RE: **Eagle Crest Subdivision
Drainage Report and Grading and Drainage Plan
Engineer's Stamp Date 8-1914 (File: C18D064B)**

**RE: Eagle Crest Subdivision
Drainage Report and Grading and Drainage Plan
Engineer's Stamp Date 8-19-2014 (File: C18D064B)**

UPDATED
DRAINAGE REPORT

EAGLE CREST ESTATE
Albuquerque, New Mexico

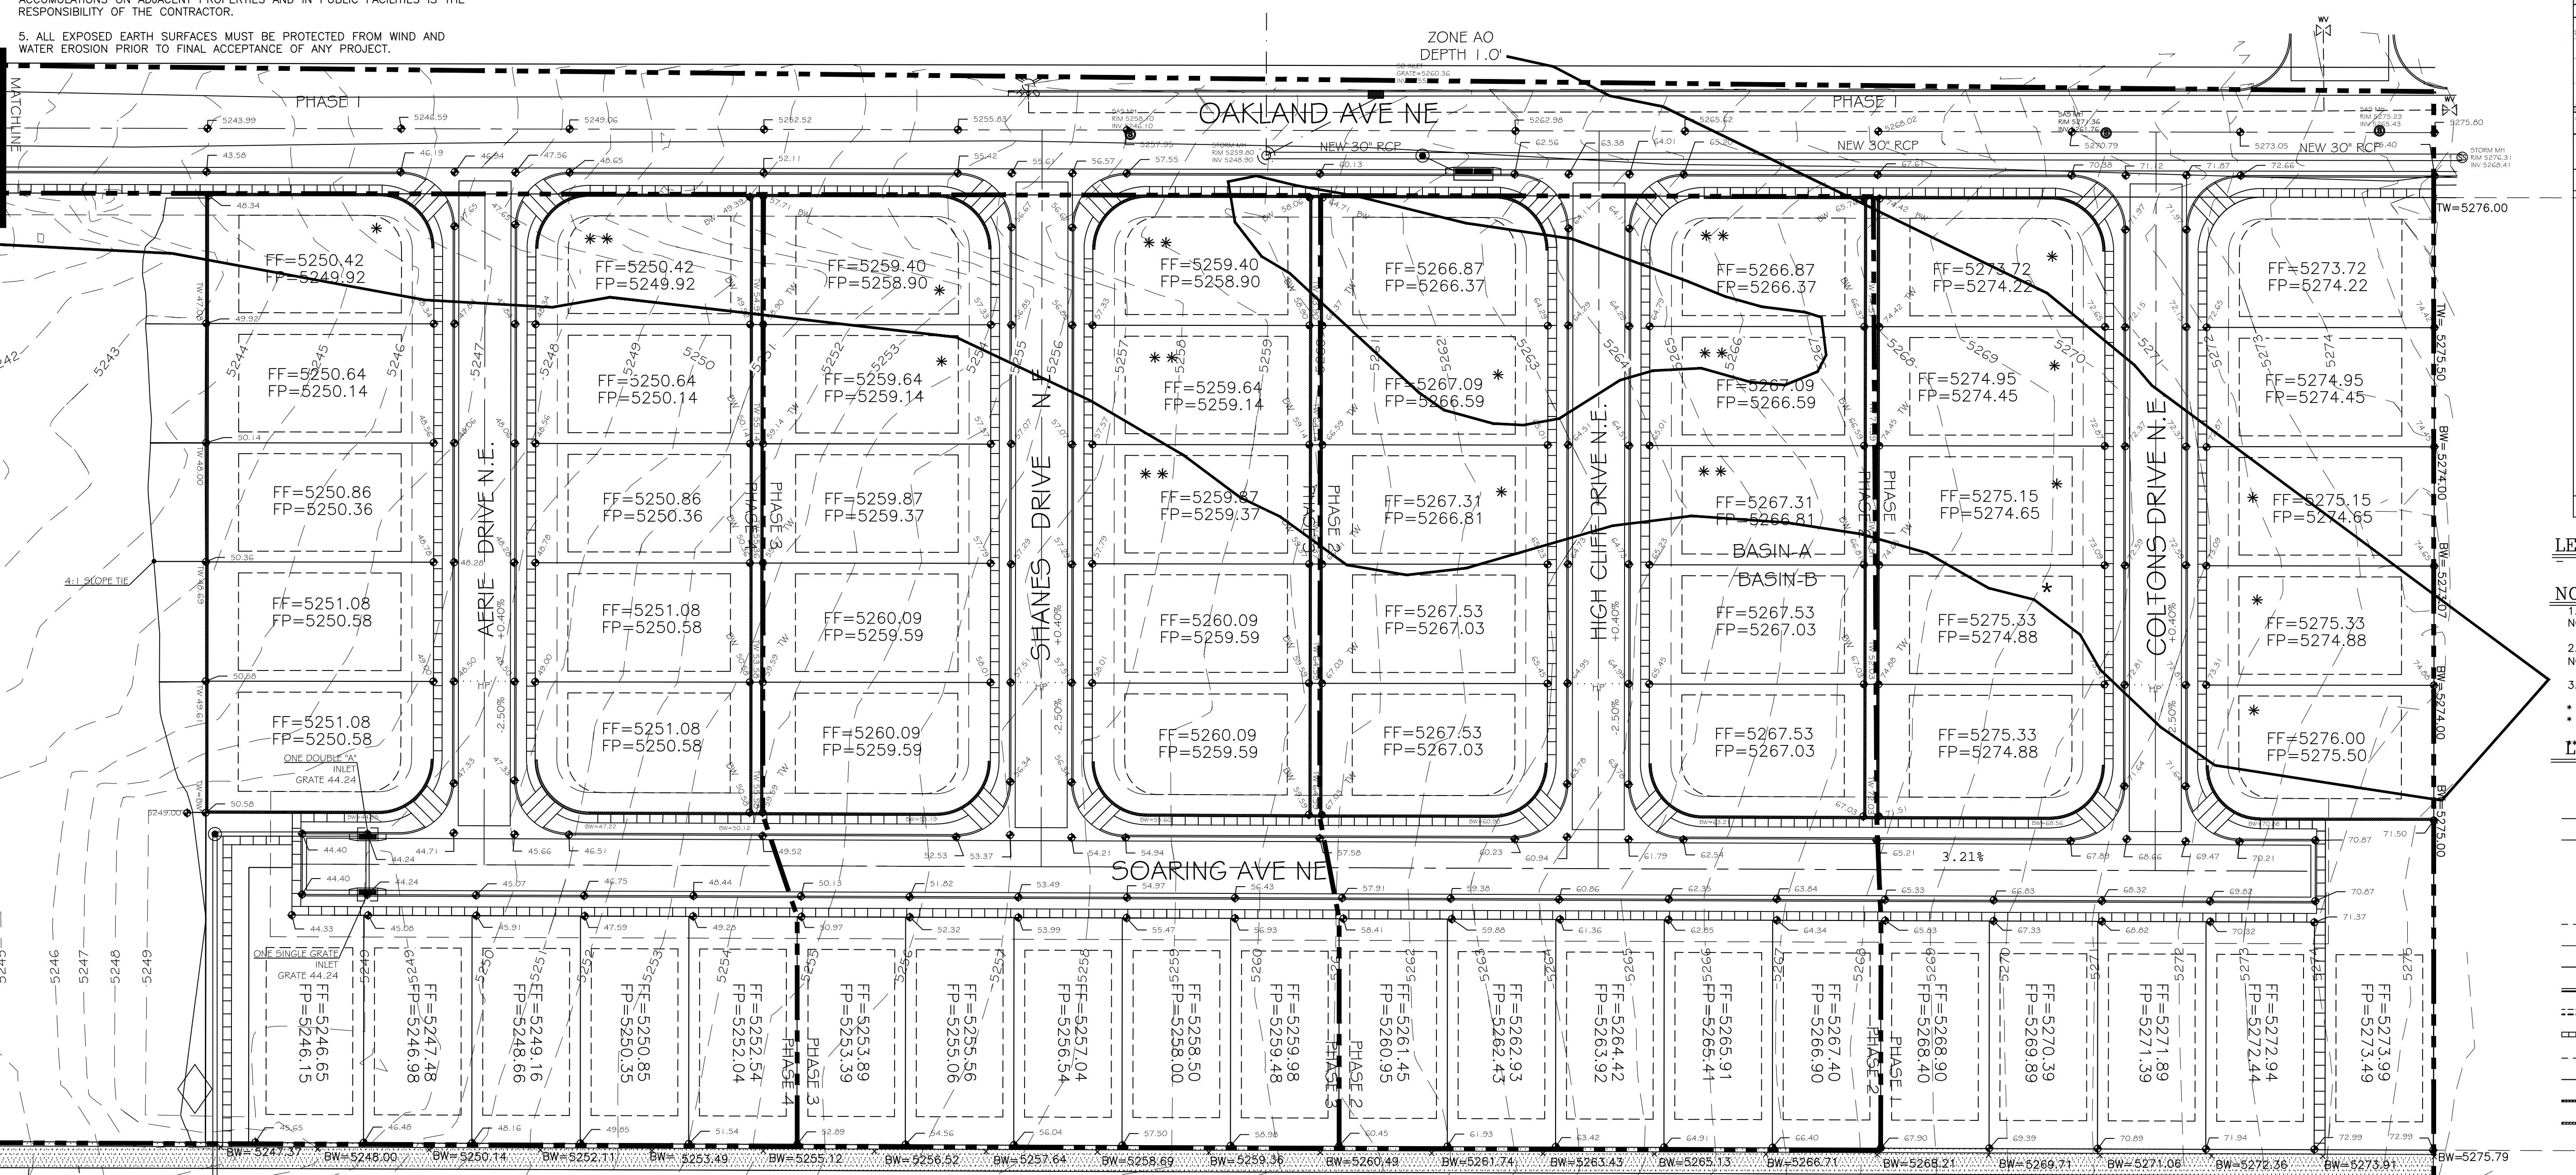
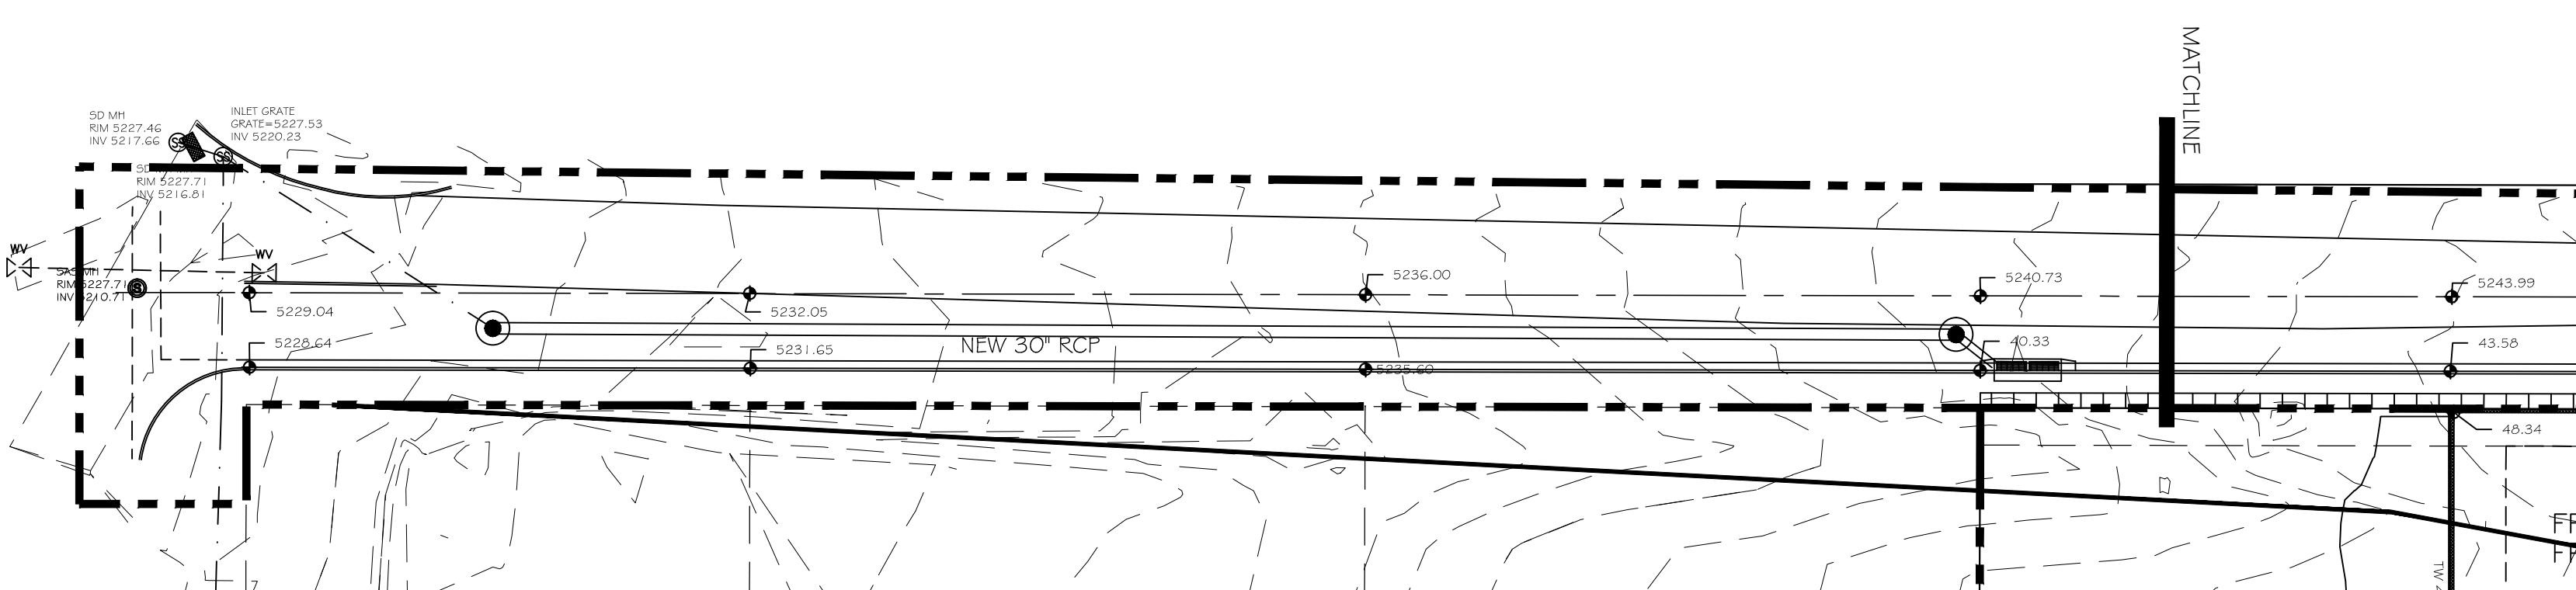
Please note that ~~since~~ the lateral pipes in Alameda are shown as 30"dia. RCP in more recent plans (as opposed to 24" RCP from earlier plans). Forthcoming as-builts should confirm this. Also, the storm drain from Soaring Avenue to Alameda (back of inlet) is sized as a 30" RCP in the report, and the DRC plans should reflect this.
